APPLICATION FOR PERCOLATION TEST

SUBJECT: AFT #6350 (Brief Road Development Co.)
Lot No. 7, Baxley Lane
11-2-73

SITE DISAPPROVAL REPORT
INDIVIDUAL SEPTIC TANK SYSTEM WITH SUBSURFACE,
SOIL ABSORPTION, EFFLUENT DISCHARGE

7) ACCURATELY DIAGRAM & DIMENSION LOT

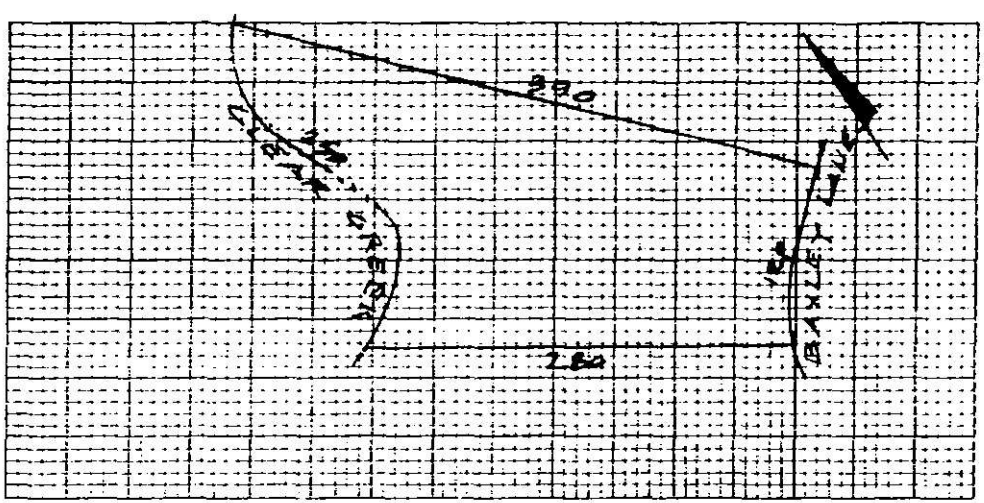
Soils were found to be fill material on the front portion of the lot (adjacent to Baxley Lane) to a depth of 12 to 36 inches. This fill material overlies an area of alluvial soils. These alluvial soils have a seasonal high water table. This factor results in inadequately slow permeability and percolation rate. The rear portion of the lot is also subject to flooding.

Based on this investigation, the lot is unsuitable for installation of a septic tank system.

__X__ ON SITE INSPECTION REVEALED LOT TO BE UNSUITABLE FOR THE FOLLOWING REASON(S) 11-2-73 - Soils were found to be fill material on the front portion of the lot (adjacent to Baxley Lane) to a depth of 12 to 36 inches. This fill material overlies an area of alluvial soils. These alluvial soils have a seasonal high water table. This factor results in inadequately slow permeability and percolation rate. The rear portion of the lot is also subject to flooding.
